**IN  
ORIGINAL APPLICATION NO.485/2023**

**REPLY/OBJECTION ON BEHALF OF RESPONDENT NO.5 (PROJECT PROPONENT) TO THE EXPERT JOINT COMMITTEE REPORT DATED 19.04.2024 SUBMITTED IN COMPLAINEE OF THE ORDER DATED 30.01.2024 PASSED BY HON'BLE NGT.**

1. The detail project report (DPR) for Khutani Small Hydro Project (SHEP) having 21 MW Capacity was prepared by Uttarakhand Infrastructure Projects Company Ltd (UIPC). Through science and technology Entrepreneurship Park and department of water resources development, Indian institute of technology (IIT) Roorkee. The said DPR was approved by government of Uttarakhand vide letter No.782/1(2)/2013-04(8)/29/2010 dated 28.03.2013. Later the DPR was revised by IIT Roorkee with cost update during 2015. The updated DPR was also approved by government of Uttarakhand vide letter No. 1103/1/2015-04(08)/129/2010 dated 30.10.2015.

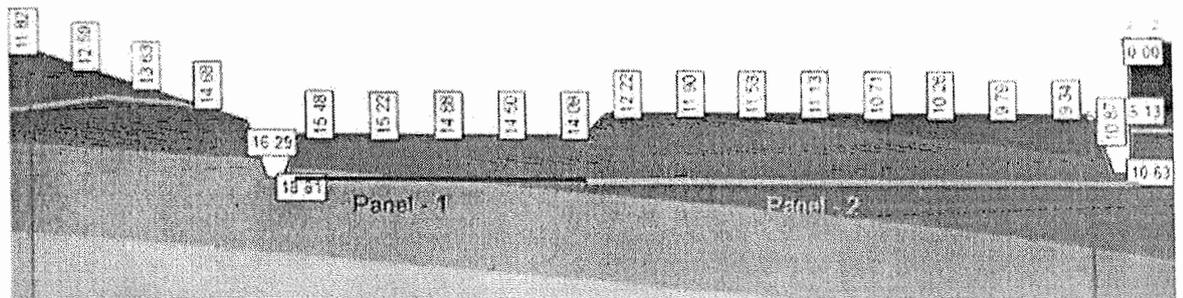
For safety consideration, around 10% more uplift is considered in design to account for the 3-D subsurface flow. For the surety of uplift pressure values seepage analysis has been carried out in Phase2 software. The result shows that the value computed with the software is around 10% higher than the value computed by the Khosla's theory. Therefore, it is found reasonable to adopt 10% more uplift pressure for the design purpose. The result of Phase2 seepage analysis is given below
